Planning Commission Work Session Agenda

Project Number	WVR 57693 & LSD 57496
Applicant	Cody Sexton
Address/Location	AR HWY 94/340
Current Zoning	Planning Area
Site Area	2.63 acres
Nature of Request	Seeking a waiver of 107-317(e) for a proposed large-scale development

DEVELOPMENT PLANS For: Dollar General of Bella Vista 17495 N AR-94 Highway Pea Ridge, AR 72751

Landscape Plan

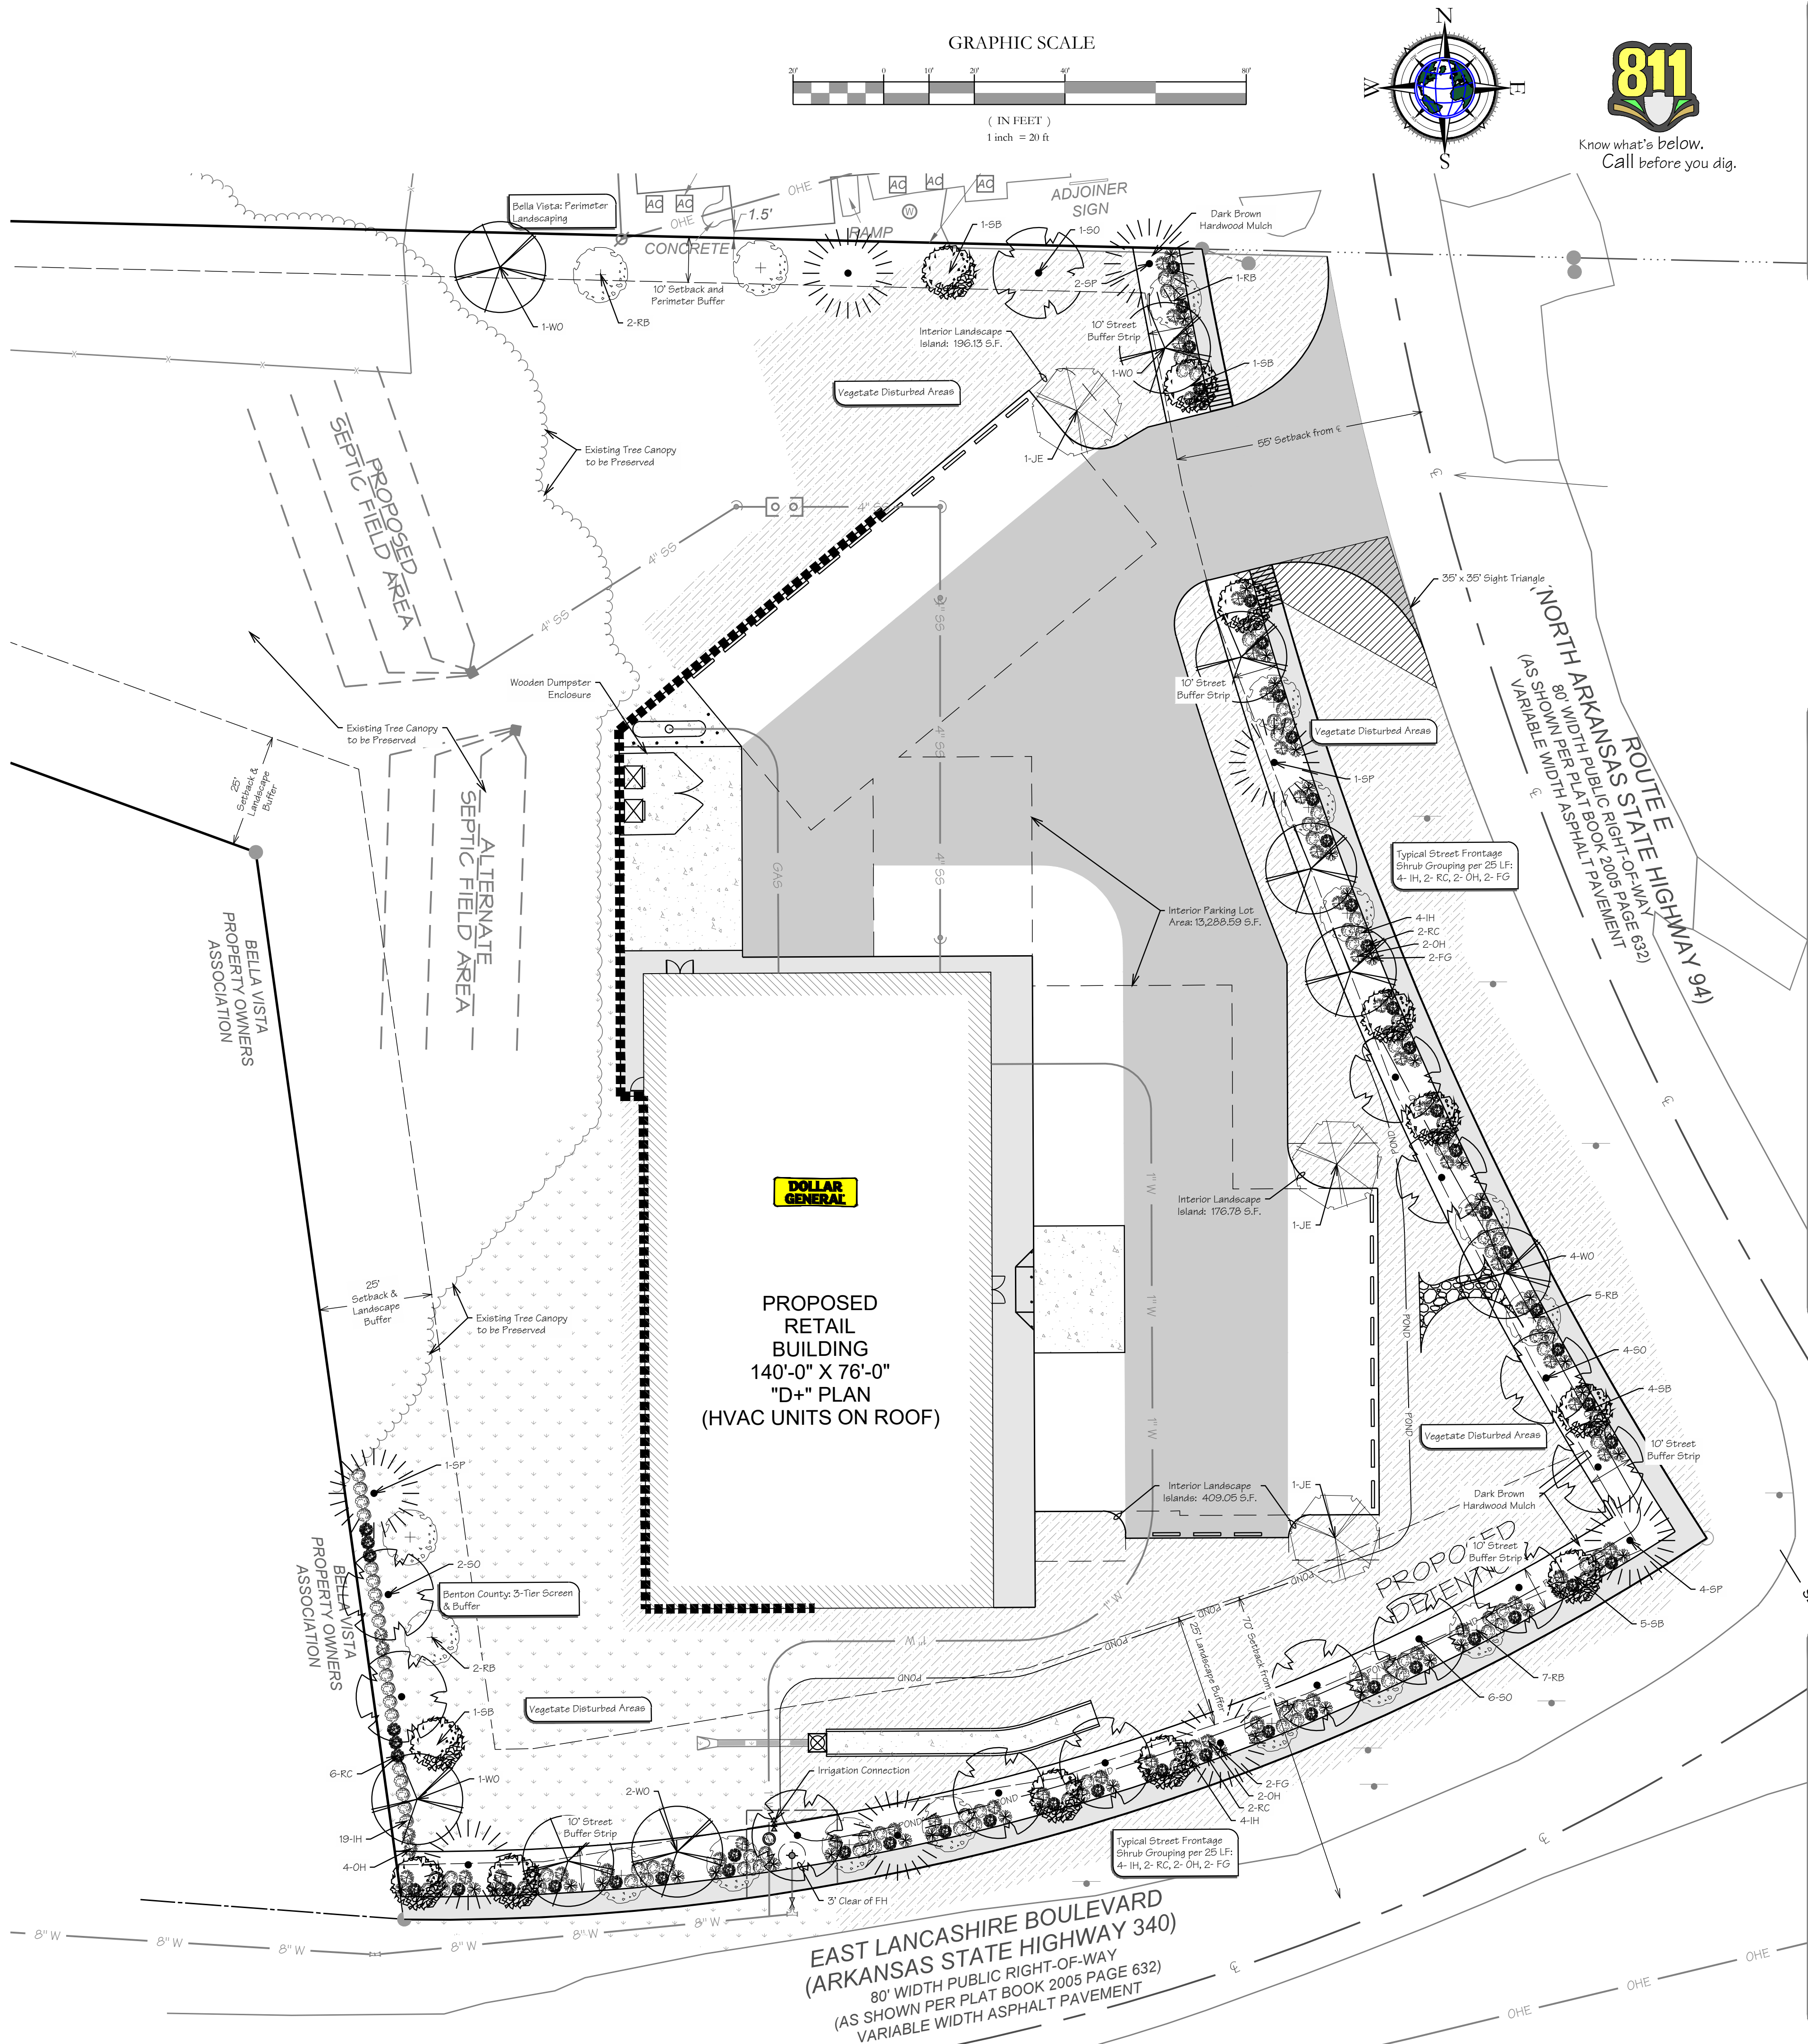
11. Show street right of way line clearly labeled. The drawing shall depict any future ROW needs as determined by the AHTD and master street plan. Future ROW as well as existing ROW and centerlines should be shown and dimensioned.

17. Show the location of all existing structure. On Large Scale Development, show location of proposed buildings and square feet. Dimension building and setbacks from the building side to property lines.

Response: Additional dimensions have been added to Sheet C2 to indicate ROW width to the

Response: Additional dimensions have been added to Sheet C2, measuring the building corners to the nearest property line.

Response: Area Usage notations have been added on Sheet C2 and are noted on the building footprint.

Response: Driveway turning radii have been increased to 30', and area dimensioned on sheet C2.

DATE:	2025-02-11	JOB NUMBER:	24-6804.02
DRAWN BY:	W. Sexton	REVIEWED BY:	W. Sexton
DRAWING NAME:	24-6804.02 Civil 002.dwg		
SHEET NUMBER:	C5

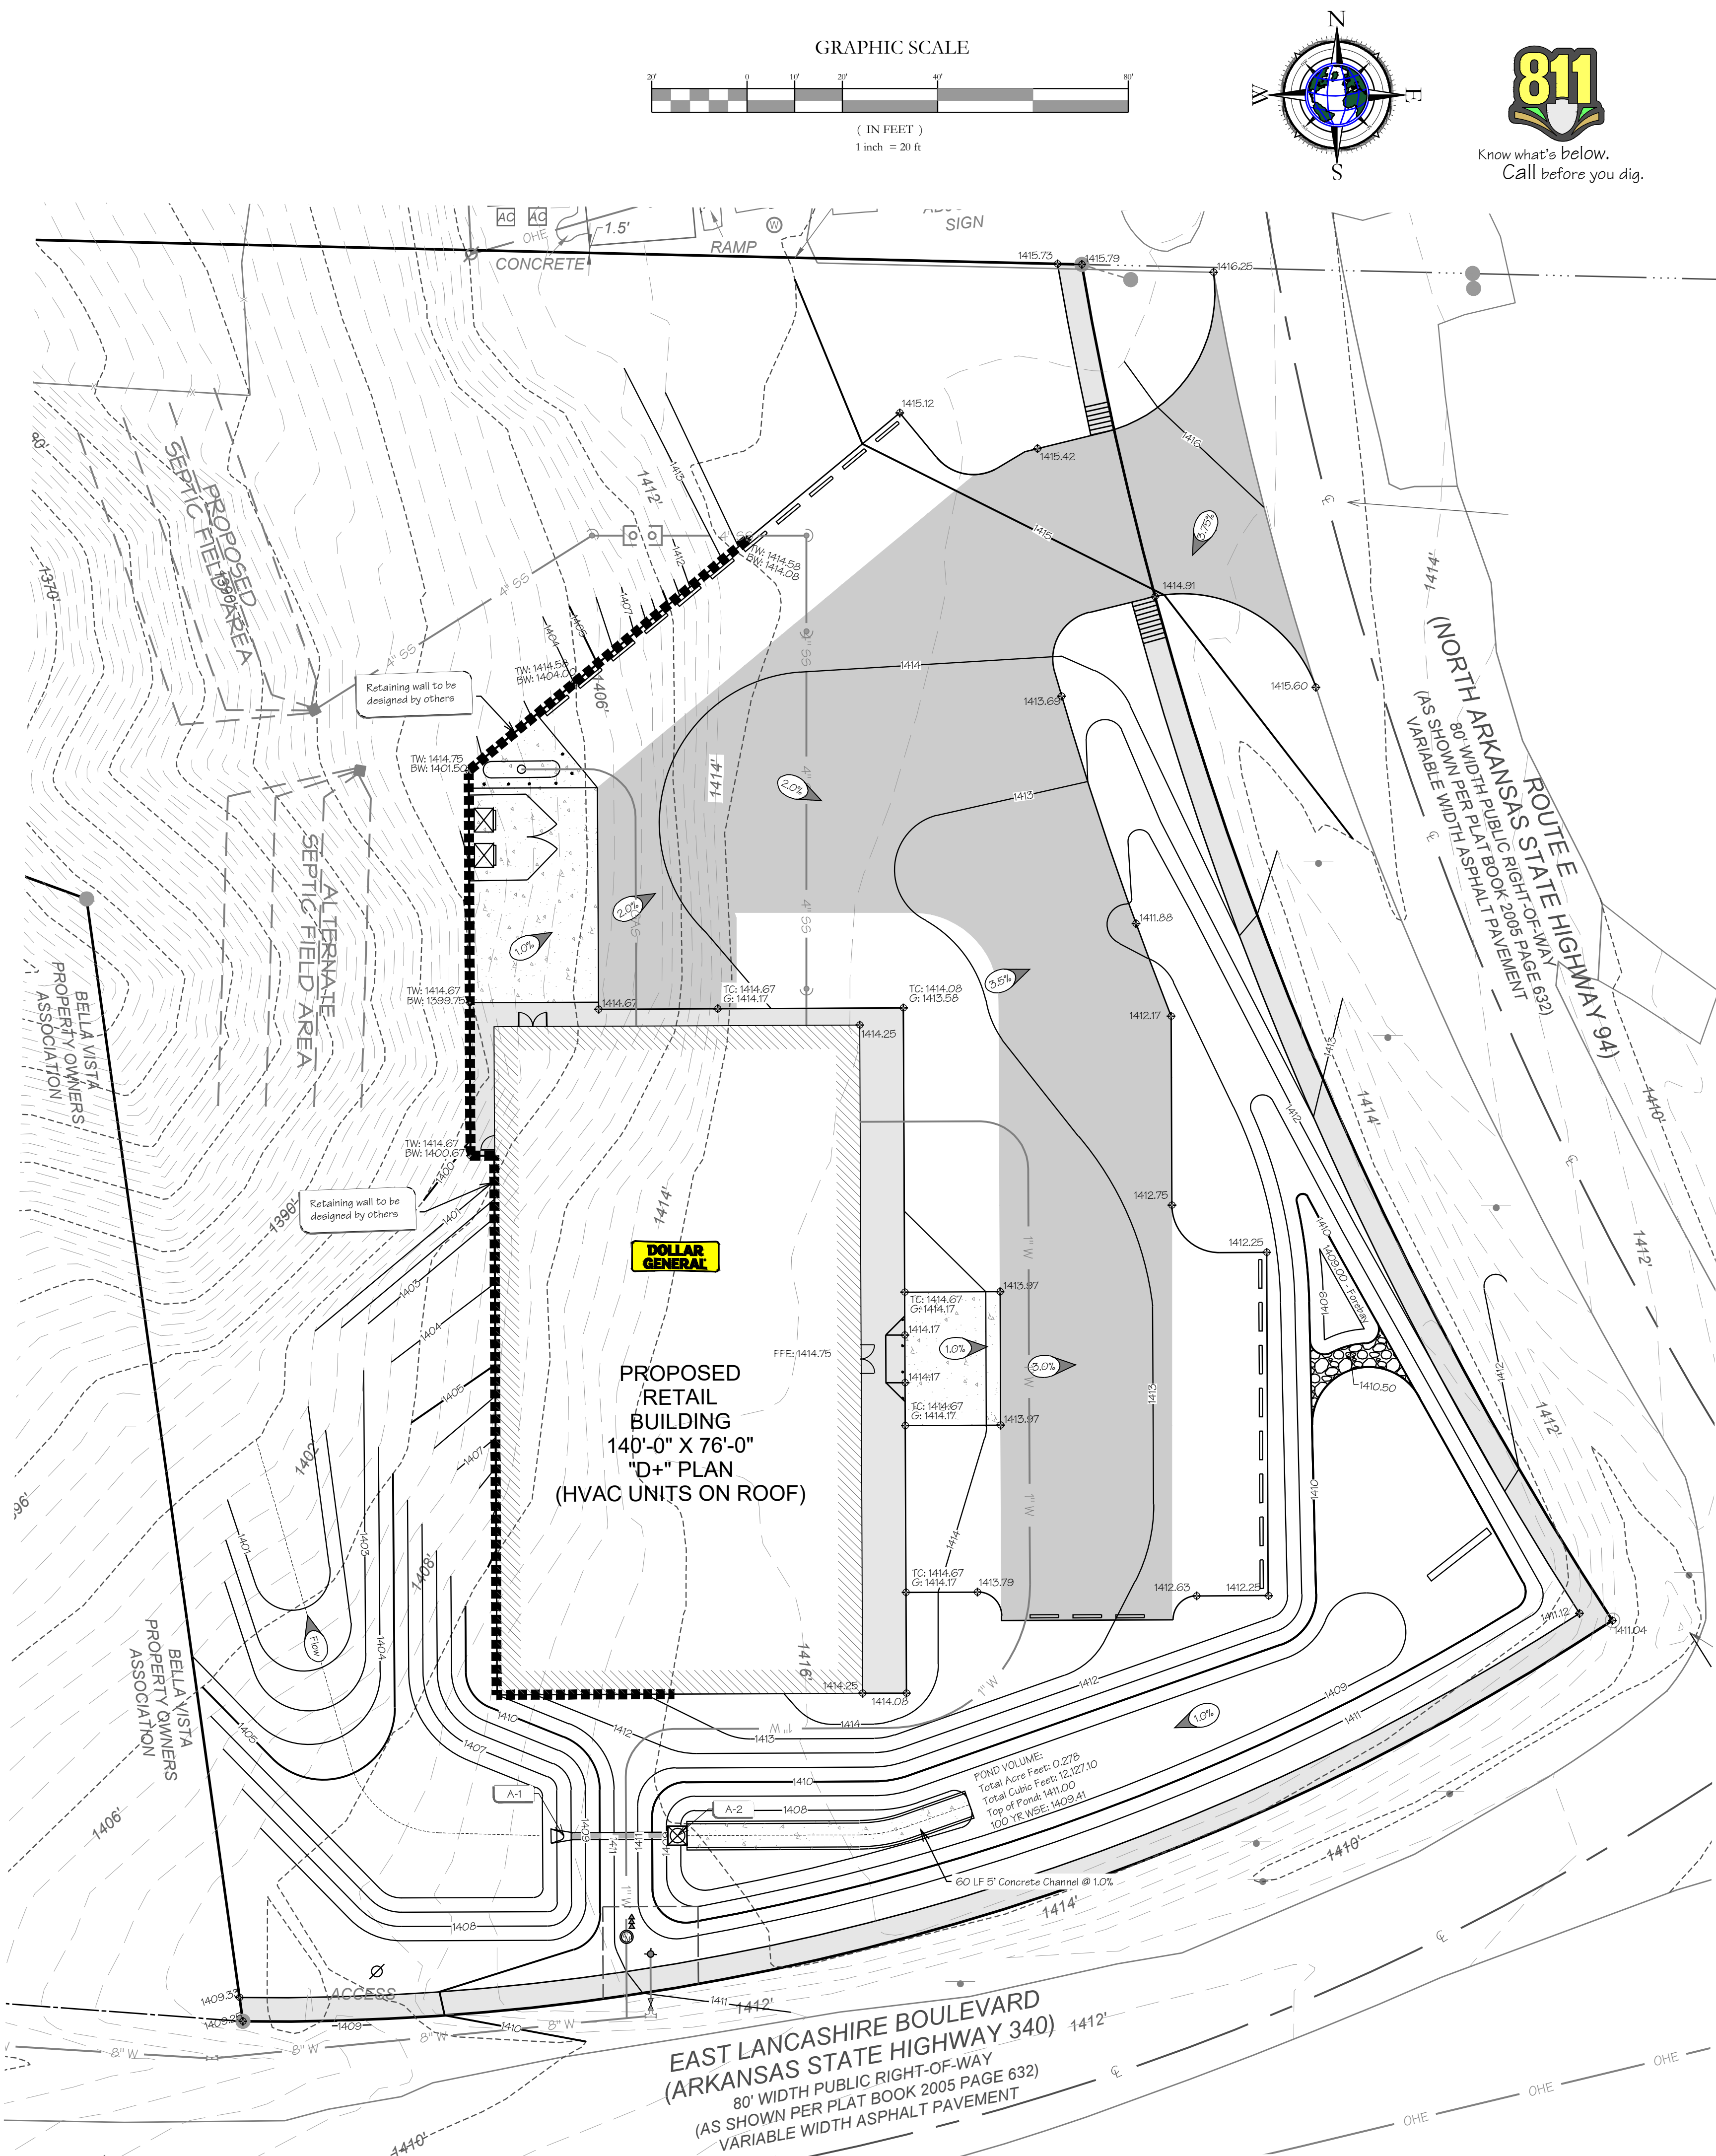
25. If a septic system is proposed, indicate it on the plat or plan. Show proposed location of septic tank and lateral fields including detail of leachate pipes and drain fill material. Show primary and alternate lateral field areas.

Response: Approved Septic Permit is attached. Alternate lateral field locations have been illustrated on Sheet C5.

Response: Hydrant Flow Data has been provided by Bella Vista POA Water and is listed on a chart on Sheet C5. The Mechanical Electrical Plumbing team has been informed of the suggestion for a booster pump for the service.
